UNITED STATES
NUCLEAR REGULATORY COMMISSION

SUBJECT: GENERIC FUNDAMENTALS EXAMINATION RESULTS

FACILITY COMMENTS AND NRC RESPONSES FOR THE OCTOBER 1996 GFE

FACILITY -- SOUTH TEXAS PROJECT

QUESTION: 14/42

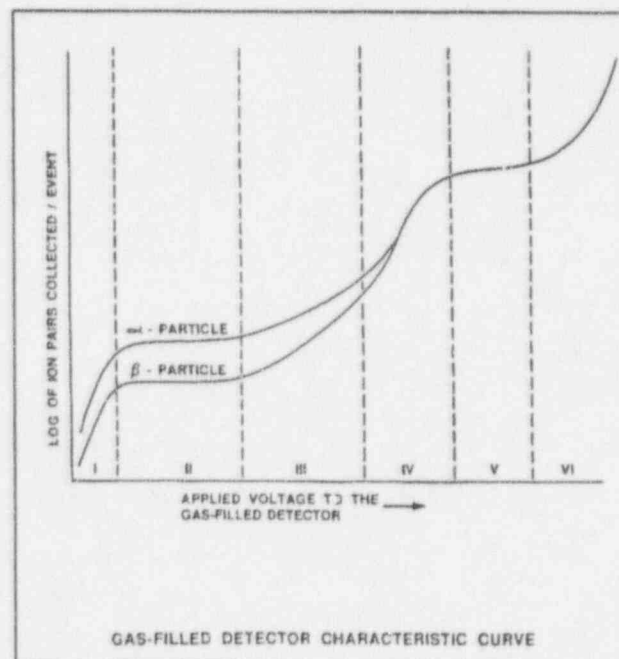
The figure provided with the question does not accurately represent a Gas Filled Detector Characteristic Curve in that it shows a disproportionality in Region III, the Proportional Region. The detector response in Region III should show a direct proportion for each of the two characteristic curves shown and they should parallel one another throughout this region. These attributes are shown in the Sourcebook on Atomic Energy, Third Edition (Glasstone), page 200 and Nuclear Reactor Engineering, Third Edition (Glasstone & Sesonske), page 311. The figure provided with the question depicts the curves as being disproportionate with respect to each other.

Because a more direct proportionality actually exists than was depicted on the exam question, operation of a detector near the high end of the proportional region would be no different than one operating at a lower point, thus we feel the question has no correct answer.

Do not concur. According to Westinghouse (Radiation, Chemistry, and Corrosion Considerations for Nuclear Power Plant Application, 1983, p. 5-29), "In a high gamma field with high operating voltage, gamma pulse pile-up results in instrument output indicating a neutron flux much higher than actually exists." This makes option B the correct answer.

Based on the interim answer key, this question was answered correctly by 23/124 examinees and yielded a very small positive discrimination index of +0.02. No answer key change is required.
